ADDENDUM TO APPENDIX E - PARRAMATTA BUILT FORM AND URBAN DESIGN REPORT

May 2024

ADDENDUM TO APPENDIX E - BUILT FORM AND URBAN DESIGN REPORT

Sydney Metro West

Figure 04: Concept SSDA (as Lodged), Plan

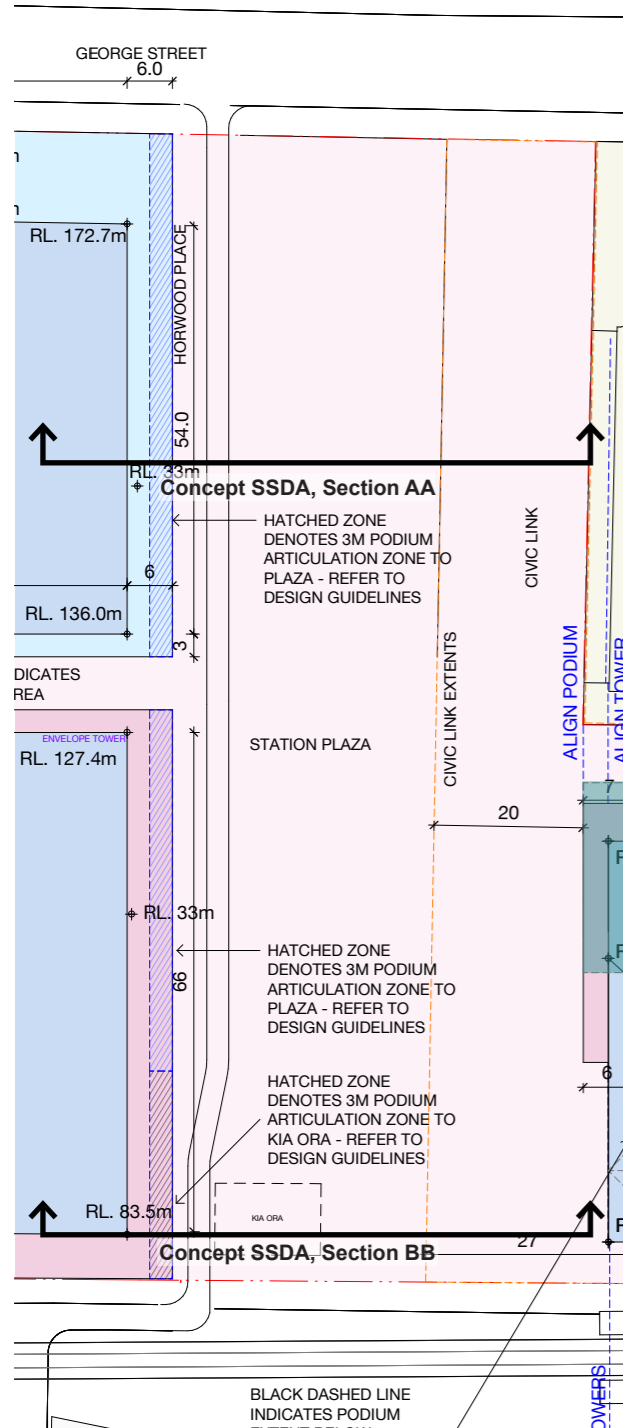
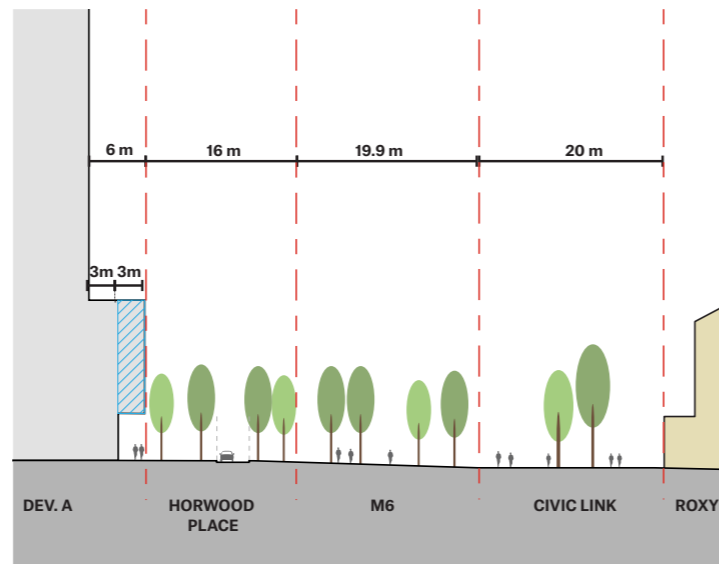
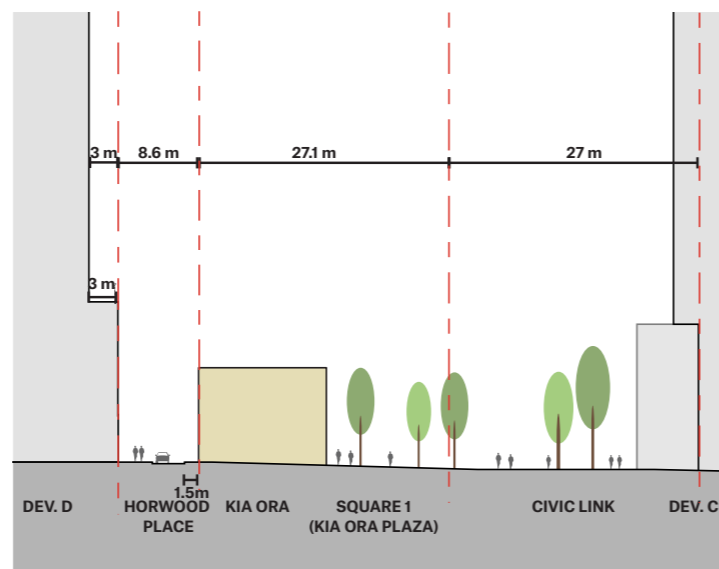
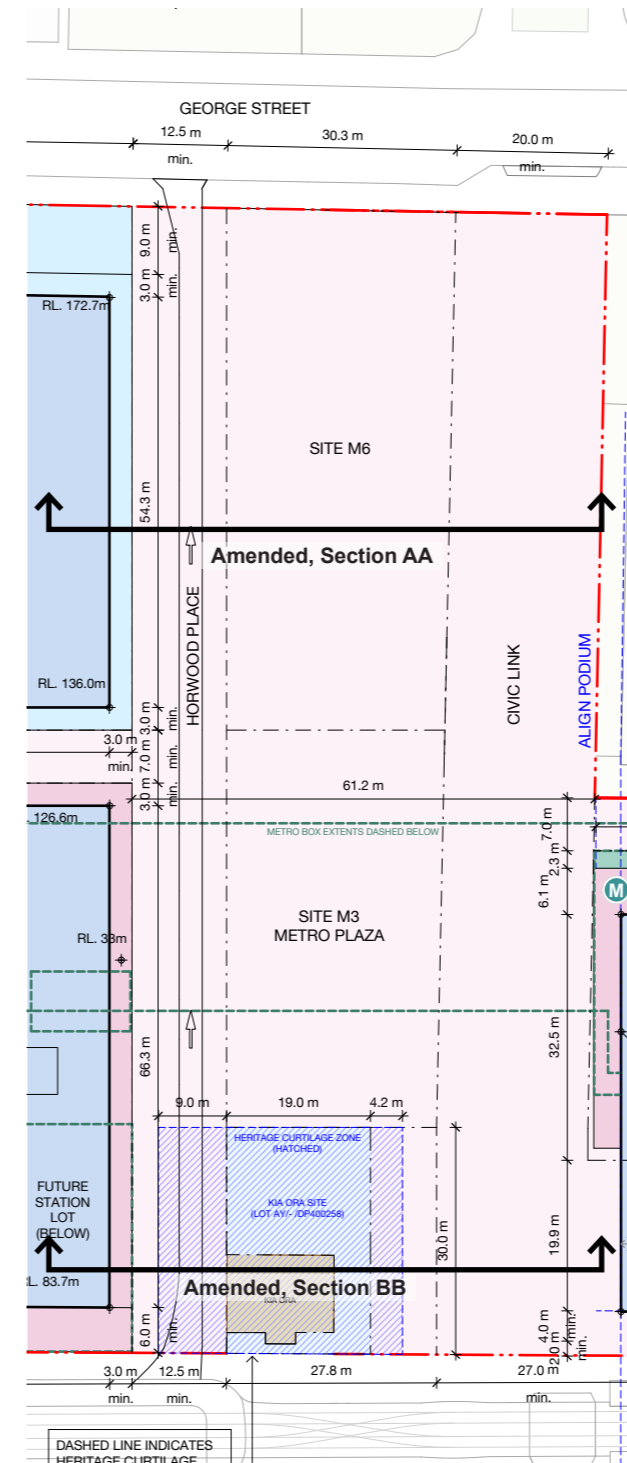
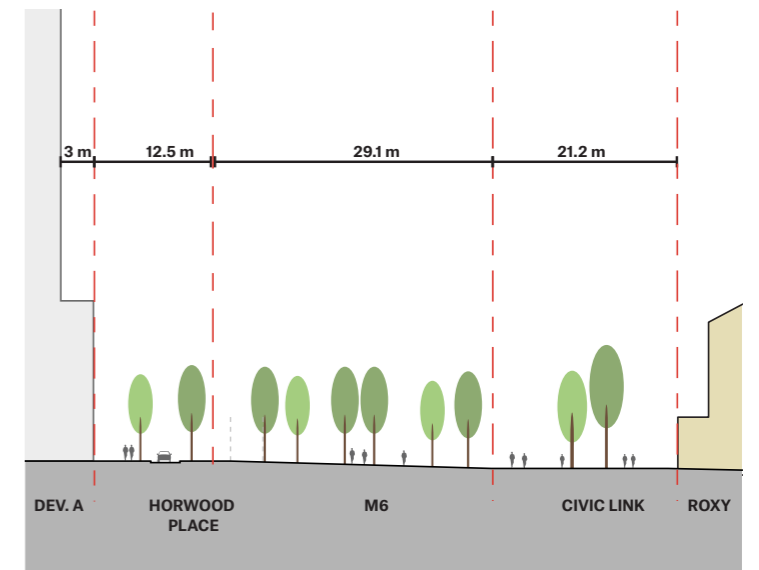
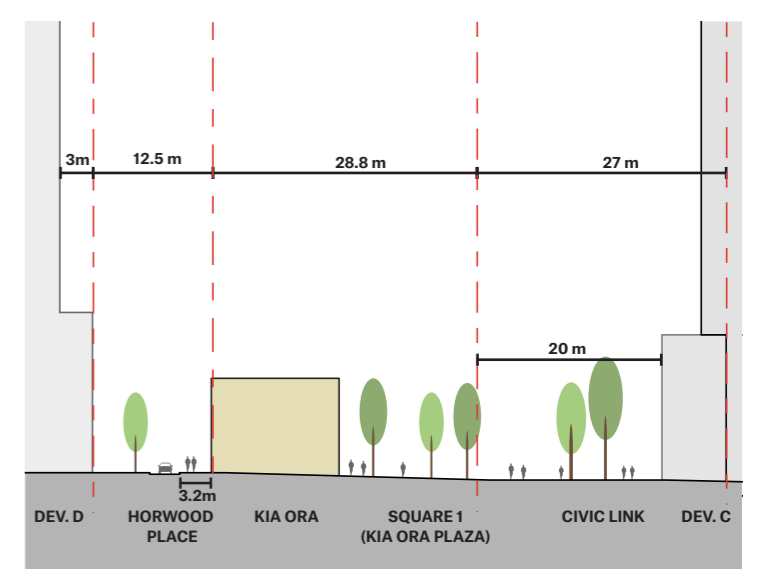
- The alignment of New Horwood Place is kinked around Kia Ora cottage. A straight street alignment with a 14m street reserve is required (as per Council's DCP) to provide sufficient space for a footpath along the western side of Kia Ora cottage and tree planting for separation and a green backdrop to the cottage. The kinked street alignment does not acknowledge the heritage setting and visually terminates on the north-west corner of the rear façade of the cottage.

The alignment of Horwood Place be straightened with a straight 14m street reservation width to accommodate parking, footpaths and tree planting along both sides of the street and to ensure Kia Ora has an appropriate curtilage and setting.

Horwood Place is designed as a single lane carriageway running northbound. A limited number of short term and accessible short term parking spaces are provided to limit the overall number of vehicles using New Horwood Place. AM peak traffic volumes are 75 cars in the AM peak (one vehicle every 48 seconds).

Figure 30: Building A Section

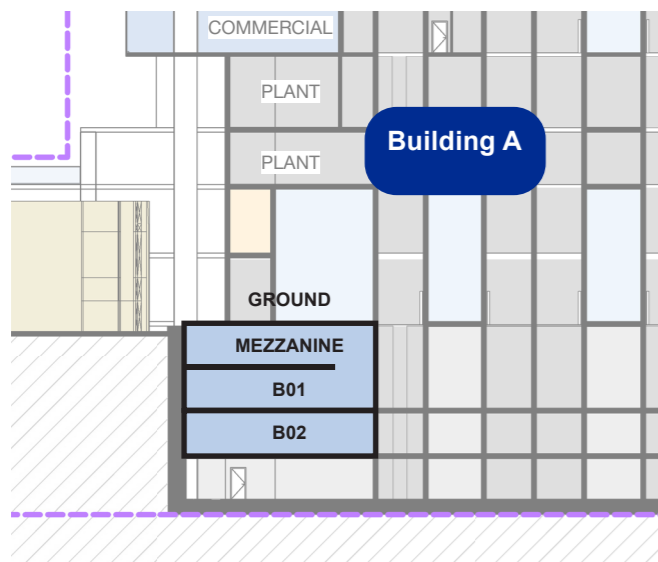
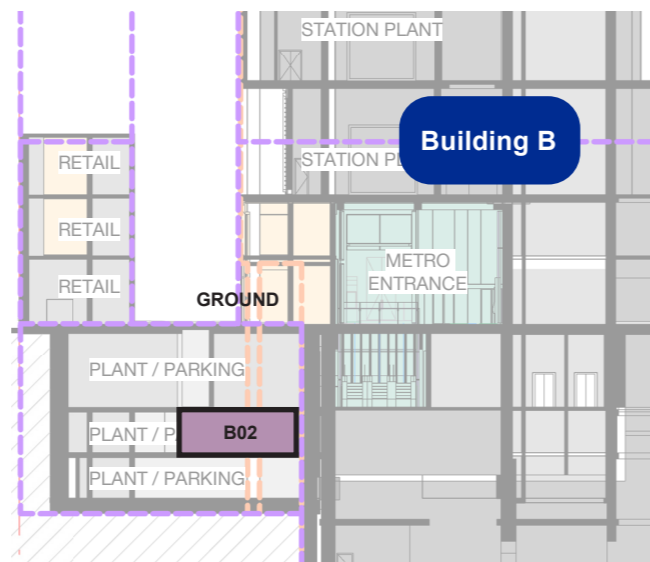
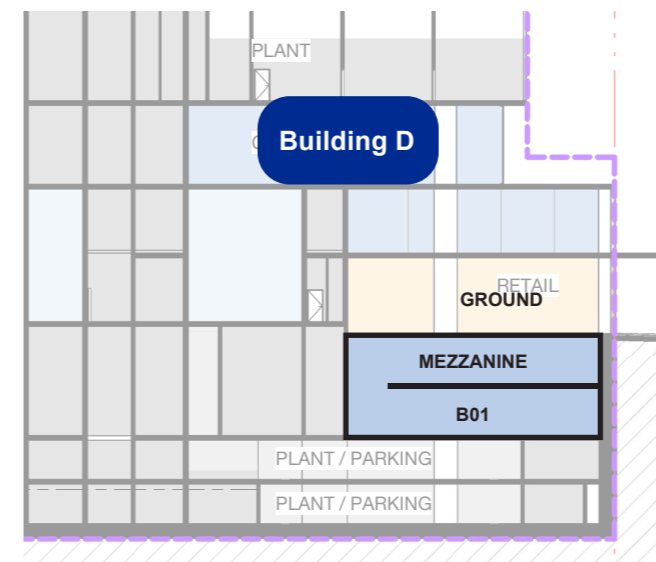
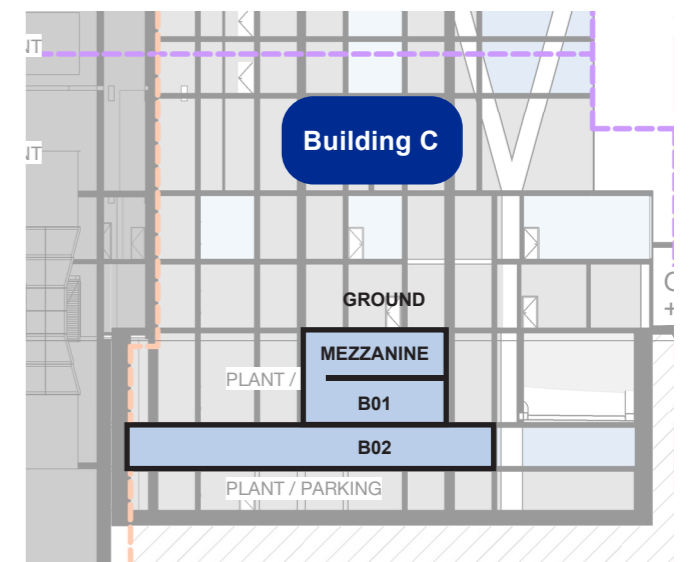
Access to end of trip facilities is to be via a ramp in line with AS2890.3 and within 1 floor of the ground plane. Stair access with wheeling ramps is strongly discouraged. AS2980.3 states "All bicycle parking should be accessible from a road, driveway or footpath via a bicycle-friendly access path".

The bikeparking locations as reflected in the indicative reference design have been placed as close to ground as possible within the constraints of the station and precinct requirements.

Those constraints have been to maximise soil depths above basement structures, to ensure all loading facilities are below ground, maximise active frontages at ground level, and minimise inactive building façades within development podiums by locating appropriate plant within basements.
